Re: Oconee Unit 2
Docket No. 50-270

Revision 2 to Babcock and Wilcox BAW-1425, "Oconee 2, Cycle 2 Reload Report," is attached to reflect the above changes in analytical method and results.

REVISION 2 TO
BAW-1425

OCONEE 2, CYCLE 2 RELOAD REPORT

UNIT 2 CYCLE 2
CORE PROTECTION SAFETY LIMIT
Figure 8-1

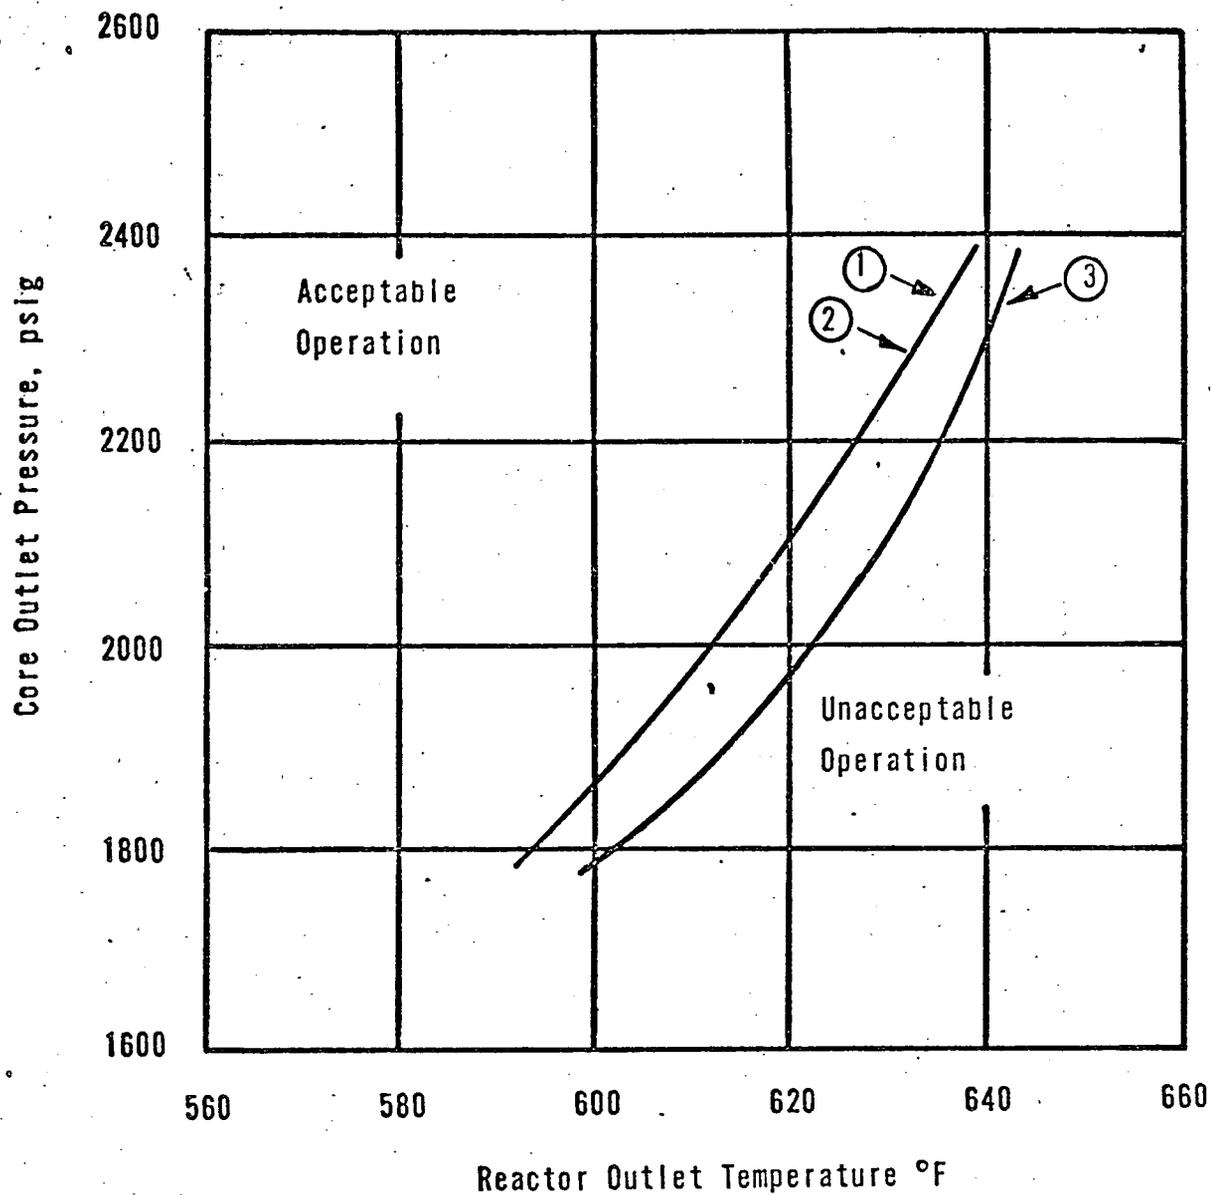
Based on the Technical Specifications derived from the analyses presented in this report, the Final Acceptance Criteria ECCS limits will not be exceeded, nor will the thermal design criteria be violated. Figures 8-1 through 8-14 illustrate revisions to previous Technical Specification safety limits.
